#### TOYOTA MOTOR NORTH AMERICA, INC.

December 18, 2023

RE: Initial Decision That Certain Frontal Driver and Passenger Air Bag Inflators Manufactured by ARC Automotive Inc. and Delphi Automotive Systems LLC Contain a Safety Defect; Docket No. NHTSA-2023-0038

Figure: Chart showing the pressure curves for one part under one temperature condition. <sup>20</sup>

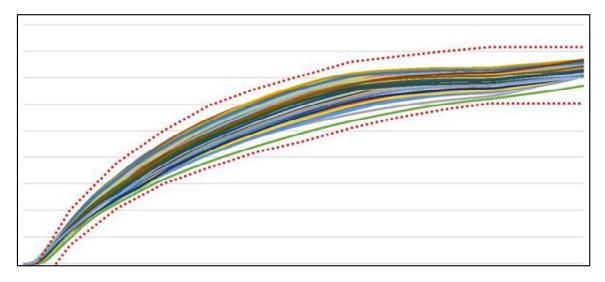
In evaluating the approximately 9,200 tank tests on Toyota-bound inflators performed by ARC, Toyota looked for potential anomalies, such as signs where the pressure built up over time slowly, potentially indicative of debris that could be restricting gas flow through the inflator exit orifice.<sup>18</sup> In this evaluation, Toyota found no pressure curves that exhibited these types of anomalies.

As an example, the figure below shows all of the daily tank tests that were performed for one particular part number at one particular temperature (a subset of the 9,200 tests). The figure shows the pressure build up over time during the course of each tank test for this subset of tests. The red dotted lines generally show the upper and lower bounds that are the specified requirements for this particular test. <sup>19</sup> Further, they indicate the shape that is expected for the pressure curve with regard to these tests. As can be seen, all of the tests for this part, under this temperature condition, show an expected and consistent result. Similar observations were made for all of the other tank test pressure curve data from the ARC testing.
